**Arborist Report**

TO: Chris Burrus - Harbour Homes LLC  
SITE: 13437 NE 100th St, Redmond, WA 98033  
DATE: February 27, 2019  
PROJECT ARBORIST: Joshua Petter  
ISA Certified Arborist #PN-8406A  
ISA Qualified Tree Risk Assessor

REFERENCED PLANS: Redmond 9 Short Plat, Source Harbour Homes LLC., Date September 20, 2018,  
Revised December 20, 2018

SITE PLAN

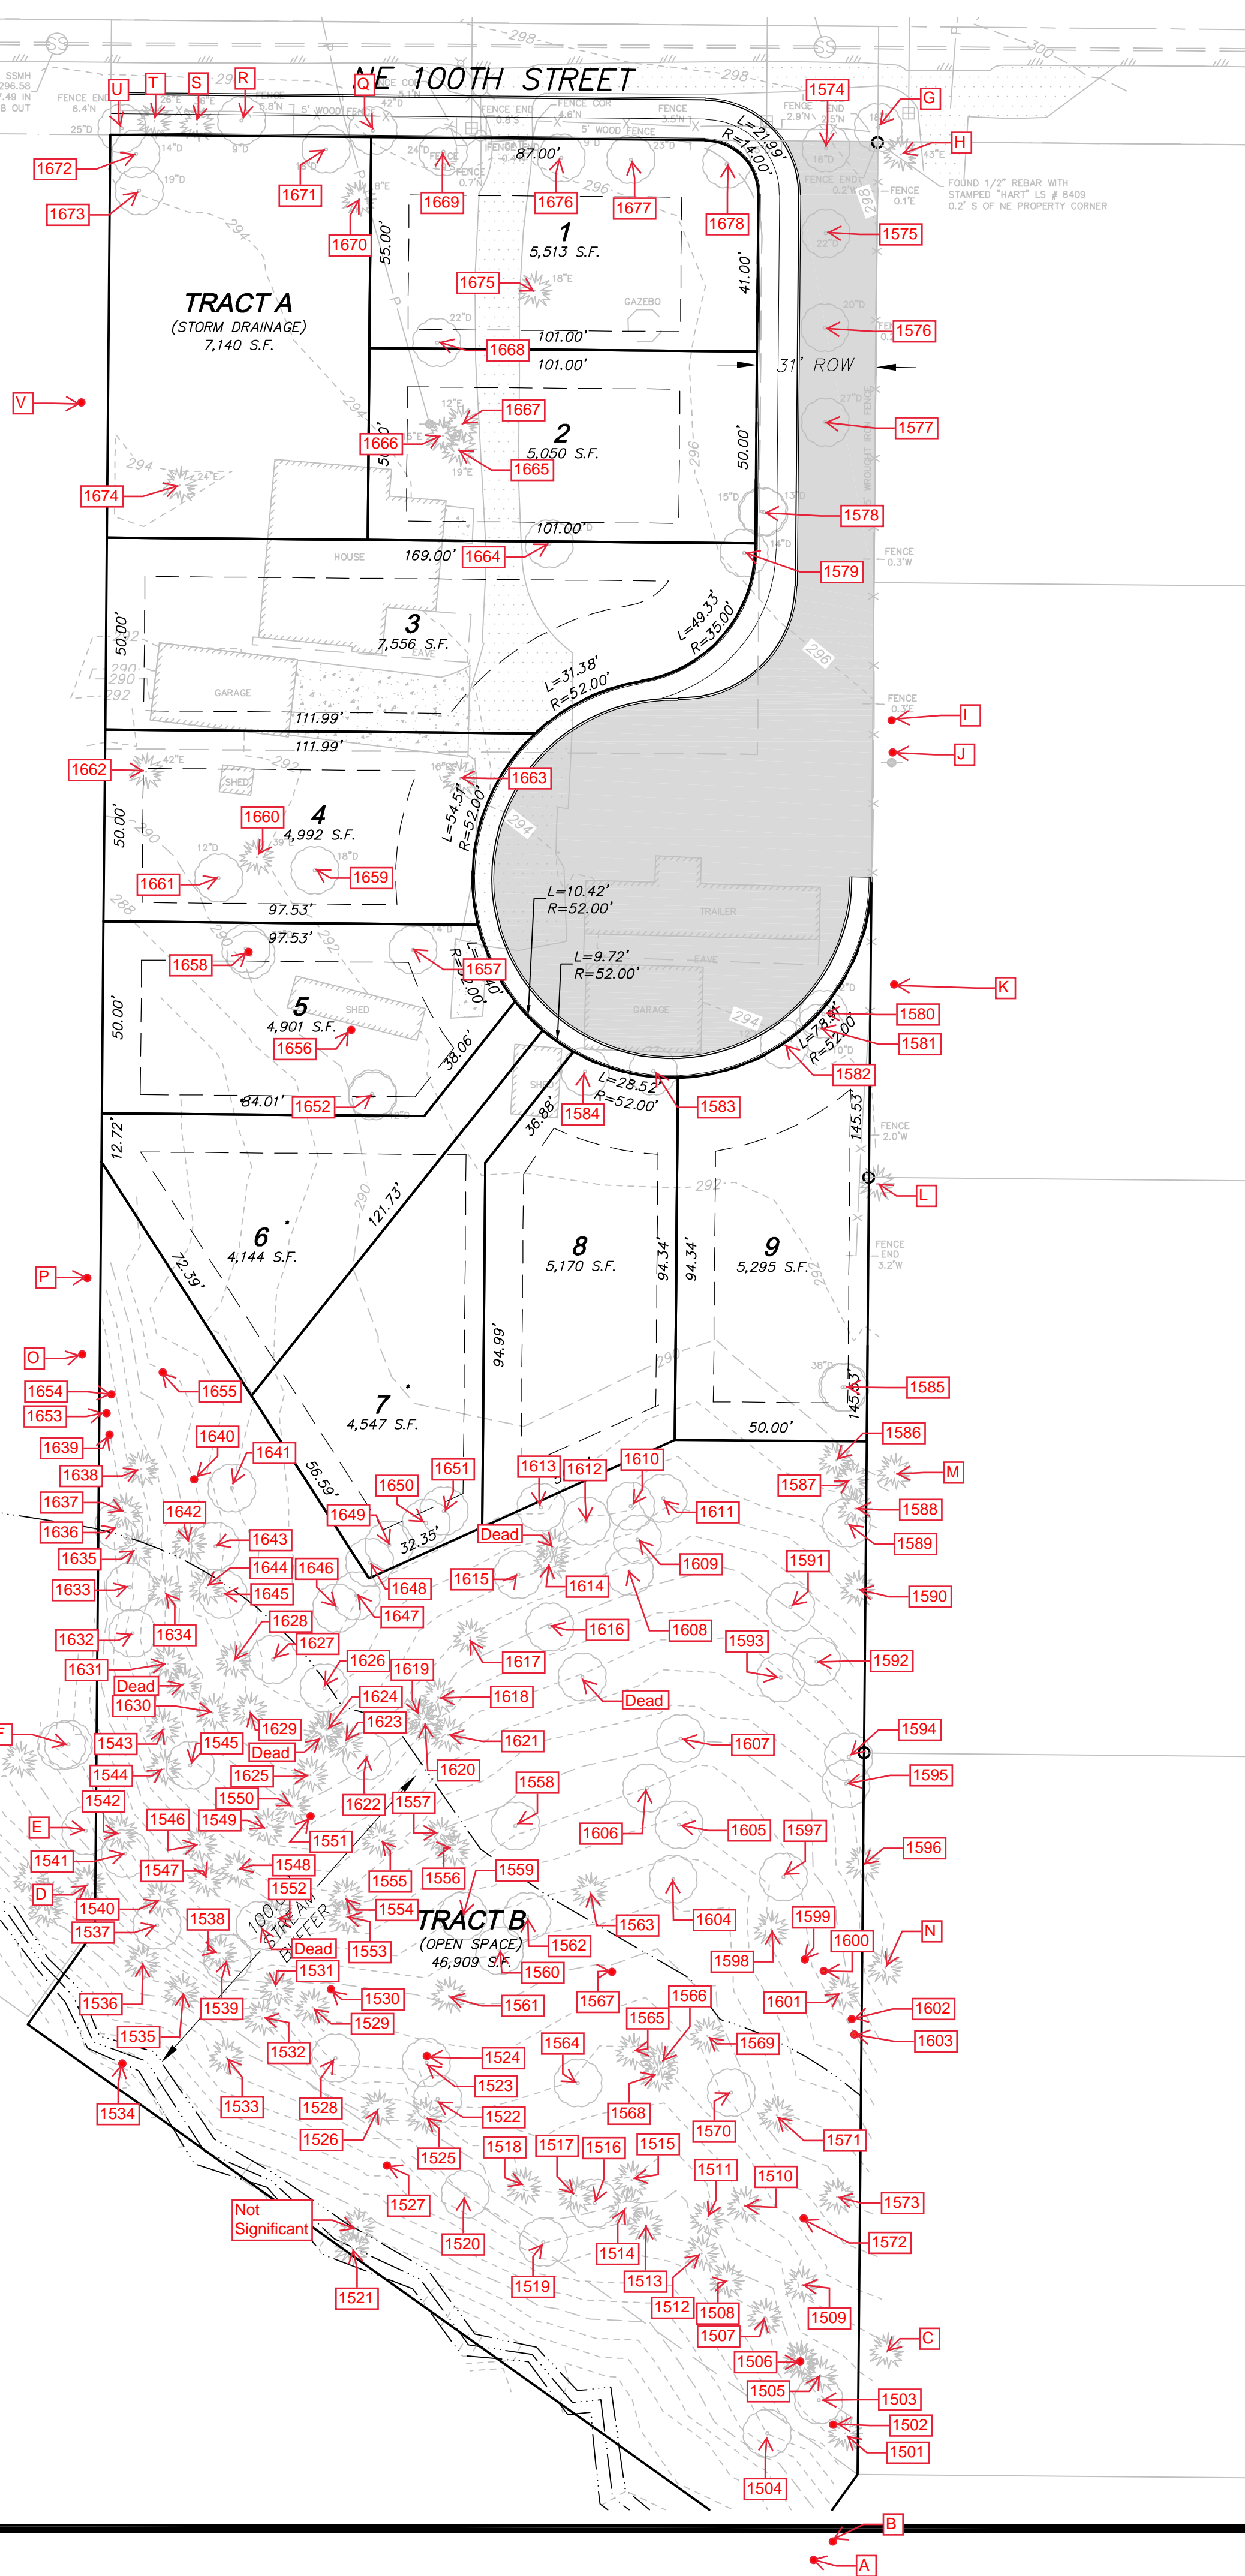
Currently, the tree protection fencing on the referenced plans is located at the dripline plus 5 radial feet. The plans should locate this fencing at the edge of the road. For trees J and K the fencing could be moved to the edge of disturbance for the construction of the sidewalk.

Trees 1615, 1616, and 1617 are proposed to be impacted by the construction of an anchor point for an above ground stormwater outflow. It may be possible to move the anchor point outside of the tree protection area for some of these trees to avoid impacting them.

Trees 1586, 1589, 1609, 1610, 1611, 1612, 1613, 1641, 1649, 1650, 1651, and 1655, as well as offsite trees L, P, and V are proposed to be impacted by grading for housing pads and construction of a retaining wall at the edge of the lot lines.

Trees 1508-1517, 1558-1560, 1562-1566, 1568-1570, 1604-1606, 1609-1621 are also proposed to be impacted by excavation for and construction of a stormwater outflow. Alternative methods of excavation such as pneumatic air excavation should be used within 5 radial feet of the dripline to prevent damage to root systems of these trees. Any necessary root pruning should be done using a sharp saw under the supervision of an ISA Certified Arborist. Compaction of soil in this area should be avoided to the extent feasible. When installing silt fencing within the tree protection area the base of the silt fence should not be dug into the ground. Instead it should be secured using a material such as gravel above the existing soil surface in order to minimize soil and root disturbance. Any work beyond the stone retaining wall must be conducted with hand tools.

The retaining wall on the southwestern corner of lot nine would impact 1587-1589 and would require careful excavation under qualified arborist supervision. Pneumatic air excavation should be used in this area to identify roots and minimize root disturbance.

Tree protection specifications for offsite tree L should be taken into consideration when designing lot nine and siting the house location. Fencing location should be reassessed when individual lot plans are available.

Tree 1586 is a mature landmark Douglas-fir (*Pseudotsuga menziesii*) tree located on the southwest corner of proposed lot 9. This tree would have to be removed based on the new design of the retaining wall. This wall could potentially be reconfigured to retain the tree.

- Re-evaluate tree retention as plans are finalized, and house designs are available.
- Contact neighboring property owner to discuss tree removals if necessary, particularly tree H.
- Update plans to show removal of tree 1586, 1641, 1646-1651, and H.
- Update development plans to show tree protection measures in relation to proposed structures.
- Update construction limits on sheet 3/13.
- Update tree protection plan to include the redesigned stormwater outflow.
- Update tree protection fencing to actual locations, as it is not feasible in many of the current locations.
- Add clear numbers for trees 1613 and 1614.
- Obtain the necessary tree removal permission from the city before developing the site.
- Invasive species should be removed when developing the property.
